**Planning Board – May 22, 2017, 6:30PM**  
**City Hall Council Chambers - 3 Washington Street, 2<sup>nd</sup> floor**

## SPR-02-17 SITE PLAN REVIEW – 43 PRODUCTION AVE – LIBERTY UTILITIES TEMPORARY CNG FACILITY

Re: Response to City of Keene Memorandum dated April 27, 2017  
Comments on Site Plan Application for 43 Production Avenue  
Liberty Utilities (Energy North Natural Gas) Temporary CNG Facility

PROJECT NUMBER: 4155.00  
 SHEET NUMBER: C1

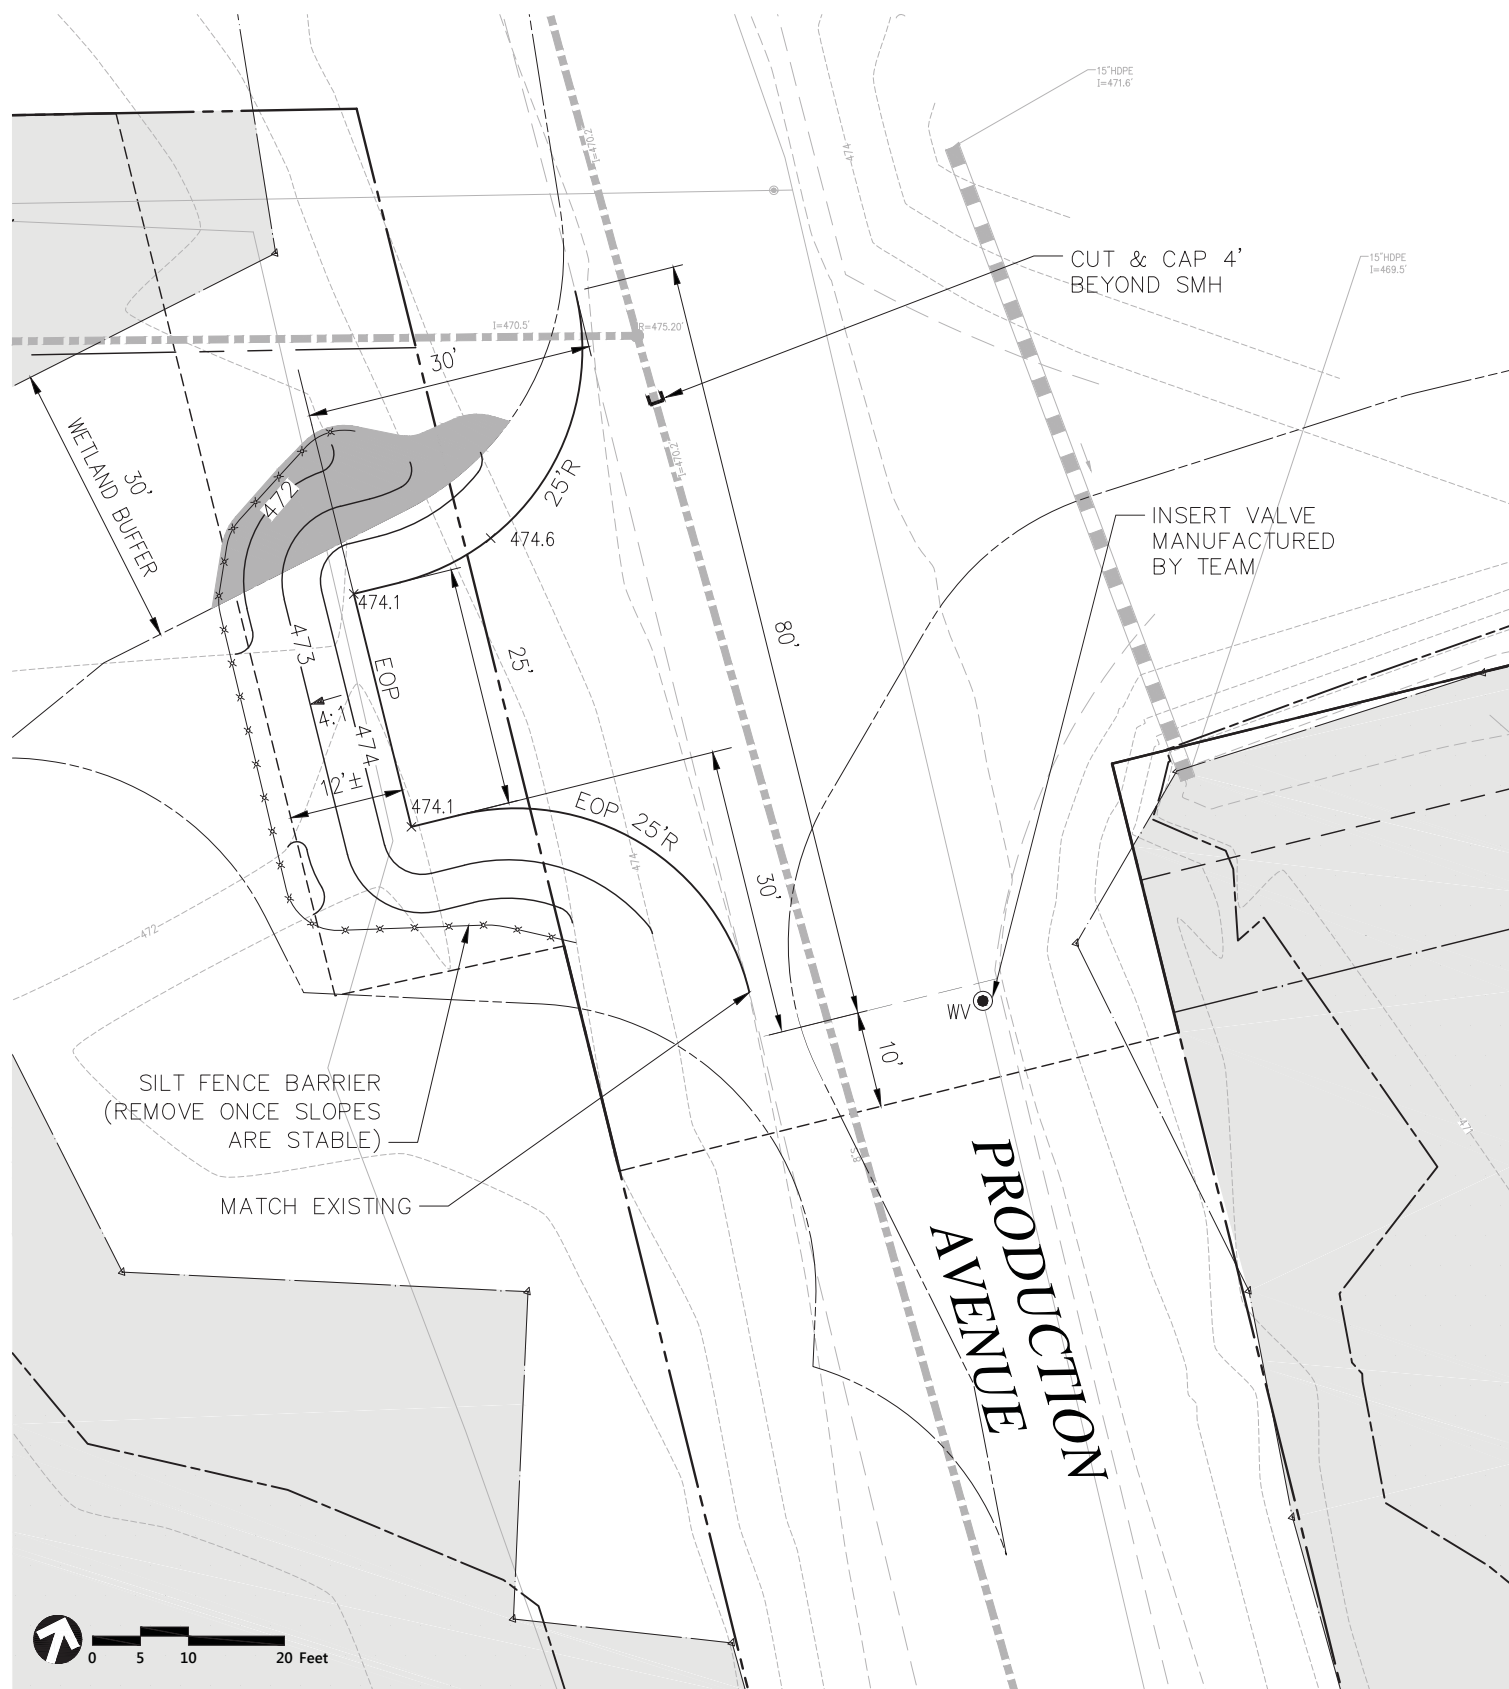
**6. The area proposed for snow storage appears to encroach into the public right of way. Please confirm that the snow storage will be entirely on the property, and revise plans to reflect this detail.**

Silt fence was proposed to be installed between snow storage areas and the wetland located on the Site. The portion of silt fence proposed along the northeastern portion of the Site which encroached on the public right-of-way has been removed. We have also slightly revised the silt fence configuration within the upland area along the northwestern portion of the Site. See revised Sheet C1.

SHEET NUMBER:  
C3

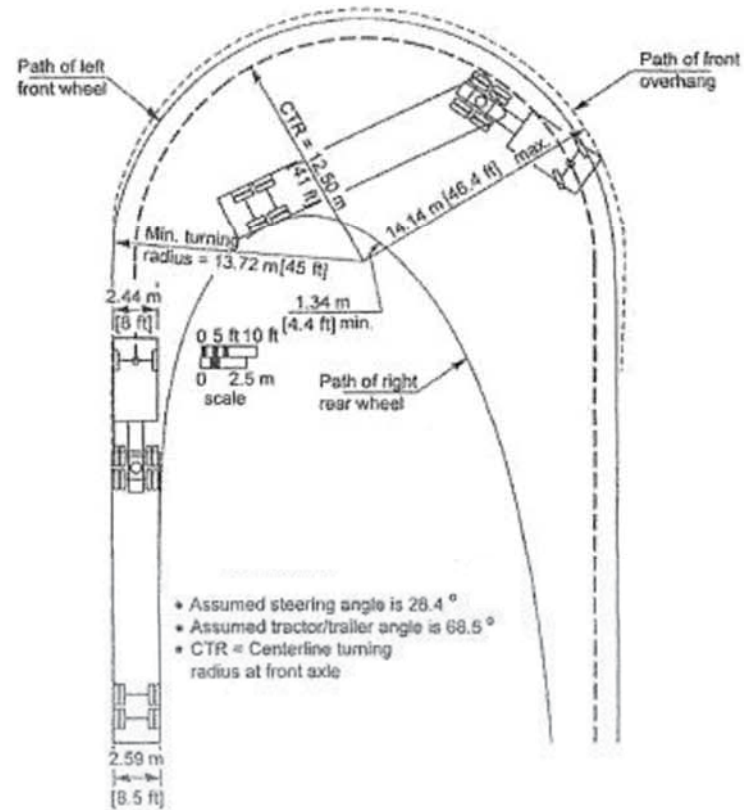
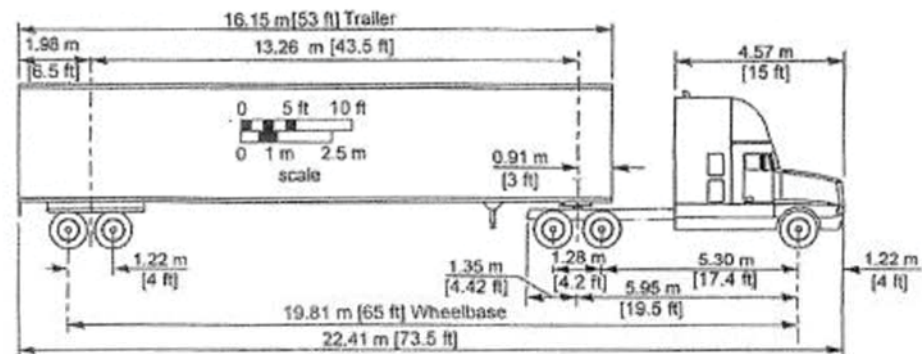
- 2. Please contact the City of Keene Engineering Division for updated standard details for work within the Right-of-Way. Planning Department Staff are in consultation with the Public Works Director to confirm that the proposed turnaround complies with Chapter 70-124 of the City Code of Ordinances. Once more information is available, staff will share this directly with you for your review.**

In an email dated April 21, 2017 to Mr. Steven Rokes (Liberty Utilities), Don Lussier, PE, Keene City Engineer, stated that the proposed turnaround complies with Chapter 70-124 of the City Code of Ordinance. Additionally, Mr. Rokes reviewed a revised draft plan of the turnaround with Mr. Lussier

on May 4. Sheet C3, Proposed Roadway Turnaround, included in the enclosed revised plan set, reflects Mr. Lussier's comments. Liberty is committed to continuing coordination with the City to ensure that the turnaround meets City standards.

The location of the proposed gate valve has been added to Sheet C3 of the Project Plans. The location and type of valve has been coordinated with the Keene Department of Public Works.

35 of 59 C4

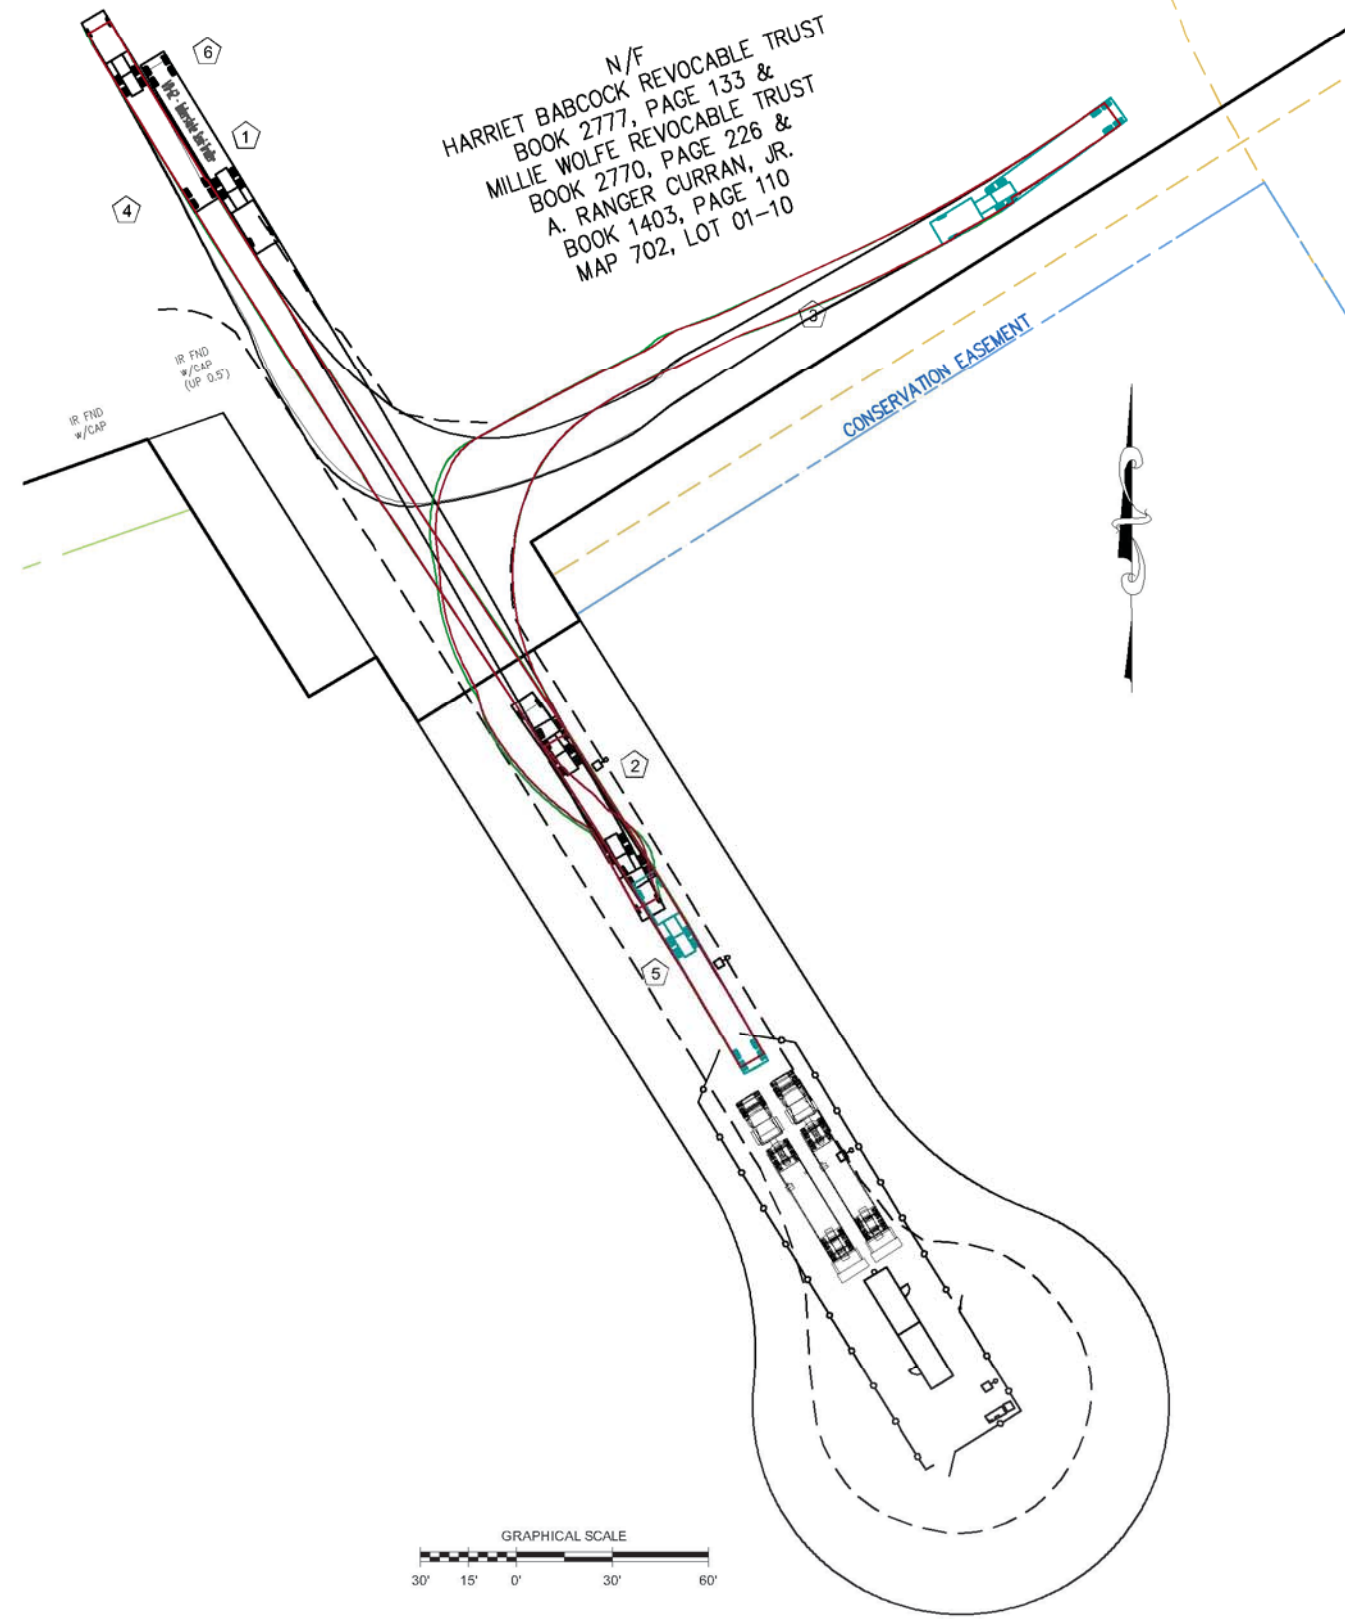
- *"Show the proposed vehicle turning radius/vehicle movement and vehicle types"*
- *"Contact the City of Keene Engineering Division for updated standard details for work within the Right of Way"*
- *"Show the location of the proposed gate valve"*
- *"Provide details for sedimentation/erosion control"*

The proposed CNG tanker vehicle movements are shown in a new plan, Sheet C4, Truck Turning Plan, attached. The design vehicle for this turning analysis is AASHTO WB-67, with an overall length of 73.5 ft and a minimum turning radius of 45 ft.
